Proposal for amendments to ECE/TRANS/WP.29/GRVA/2020/22

Note: This informal document aims to amend ECE/TRANS/WP29/GRVA/2020/22 to include the changes proposed below and follows the discussion held in the previous GRVA 2020 sessions.

**ACSF C – Case where the lateral movement is initiated automatically
(1 Step HMI)**

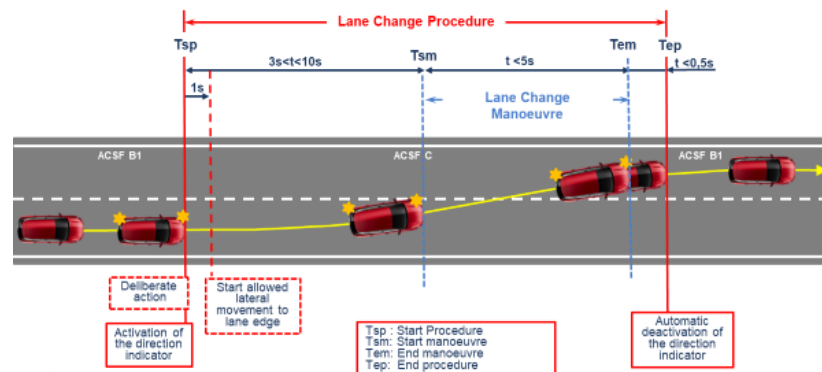
In case of an automatic initiation the lane change manoeuvre shall commence between 3.0 seconds and **7.0** ~~5.0~~ seconds after the manual activation of the procedure as described in paragraph 5.6.4.6.2. and shown in the Figure below. **The manoeuvre shall commence at the earliest opportunity when the situation is not deemed critical as defined in 5.6.4.7.**

ACSF C – Case where the lateral movement is initiated by a second deliberate action by the driver (2 Step HMI)

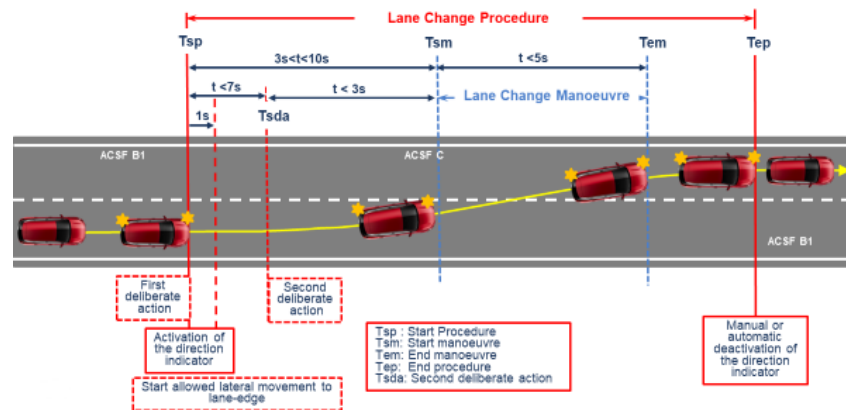
In case of an initiation by a second deliberate action the lane change manoeuvre shall commence between 3.0 and **7.0** ~~7.0~~ seconds after the manual activation of the procedure as described in paragraph 5.6.4.6.2.

Additionally, the lane change manoeuvre shall commence at the latest 3.0 seconds after the second deliberate action as shown in the Figure below.
